**Tecumseh Road West
Corridor
Addendum to Master
Plan**

July 2001

Corporation of the
City of Windsor

92-8966-03-03

**Upgraded Railway Crossings
with Proposed Crossing Protection**

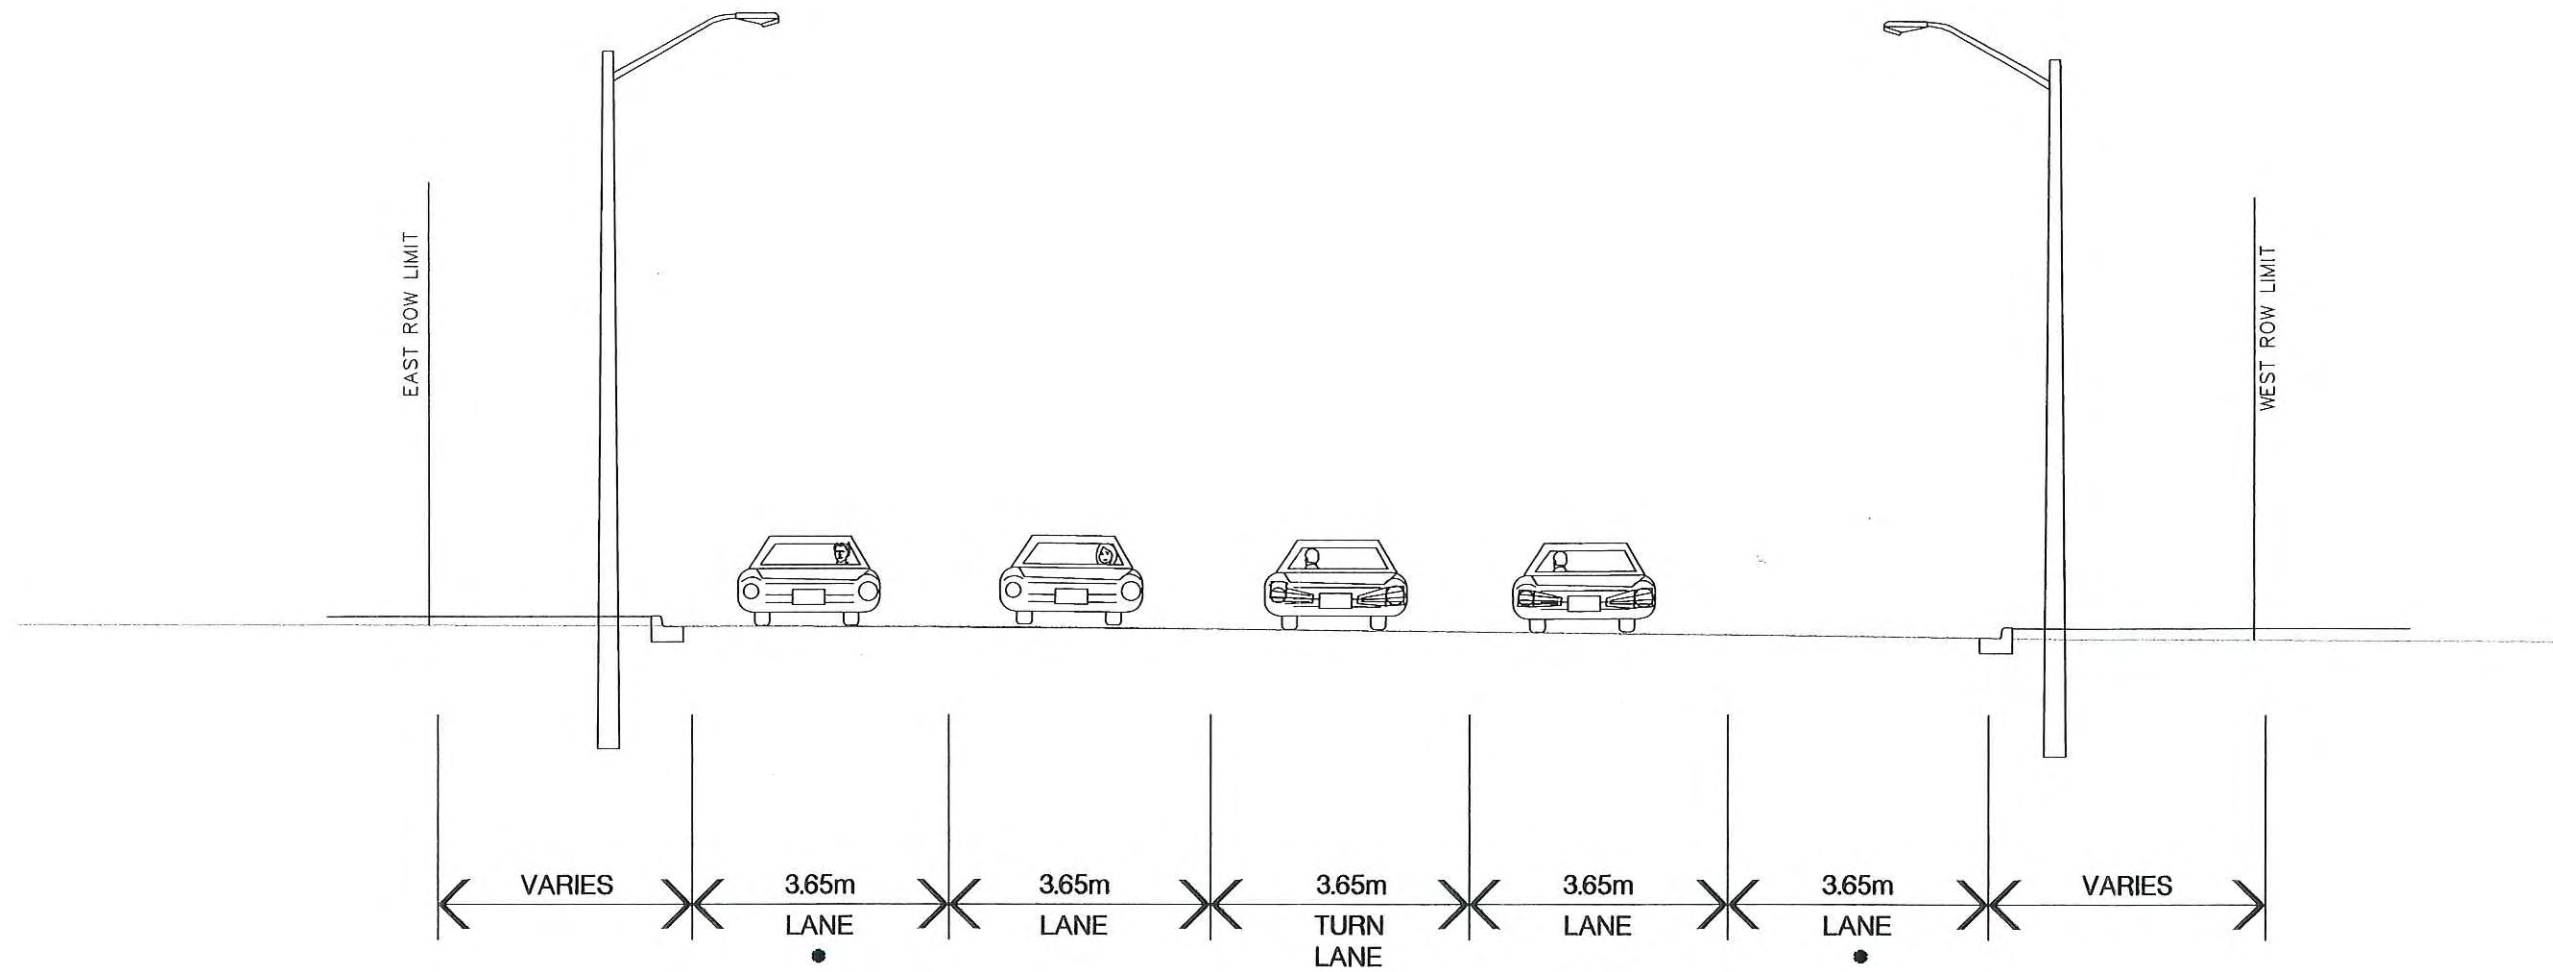
In light of the reduced railway movements at the CPR crossing, it is proposed that substantially improved and protected level crossings be constructed at each of the ETR and CPR crossing locations and that Tecumseh Road West be constructed as a five lane cross section with two through lanes in each direction and a centre two-way left-turn lane. These improvements are identified in Figure 1.

Please note however that this crossing is already equipped with flashing lights, bell and gates. Widening of Tecumseh Road West will require modifications to the existing system which may include extension of gate barriers, provision of or modification of cantilever signals or provision of additional flashing light units in the median.

Typical Cross Section

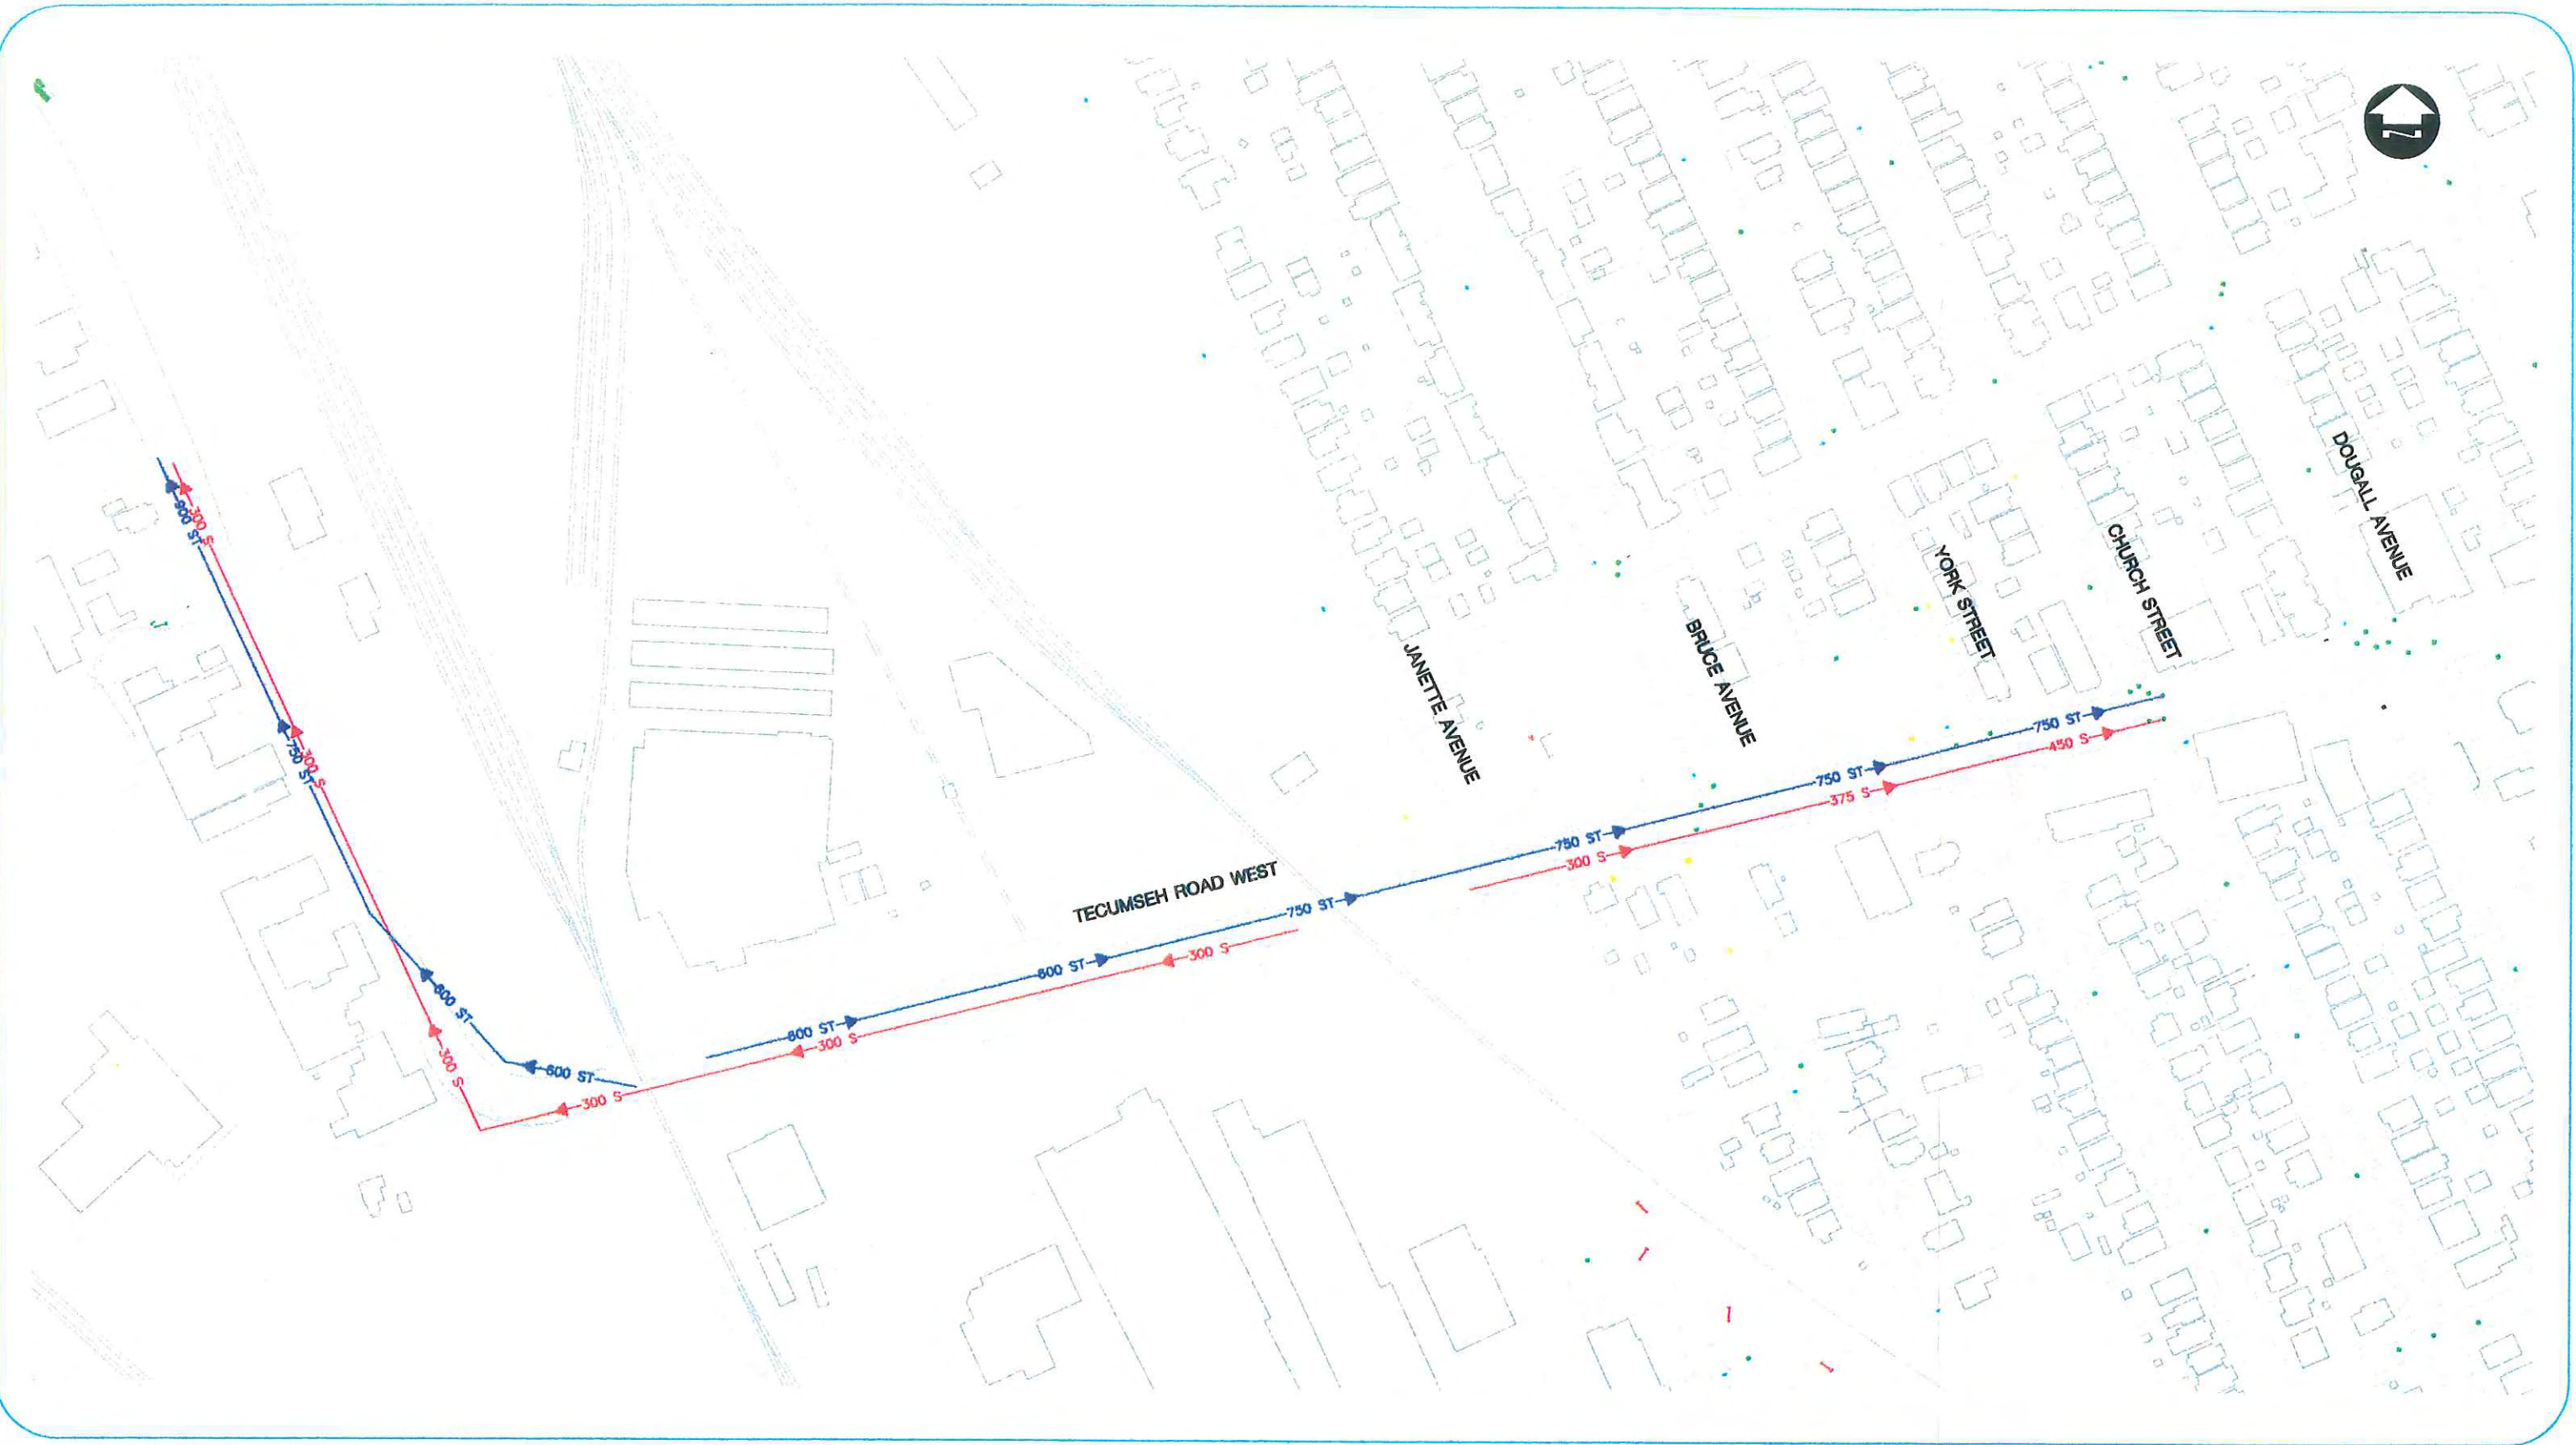
The recommended solution to address the problems at the level crossings located west of Janette Avenue on Tecumseh Road West is to upgrade the crossings, provide flashing signals, bells and crossing gates, and widen the roadway to a five lane cross-section (see Figure 2).

• Curb Lane Dimensions will be subject to the completion of an Environmental Study Report which will assess the need for on road cycling capability.
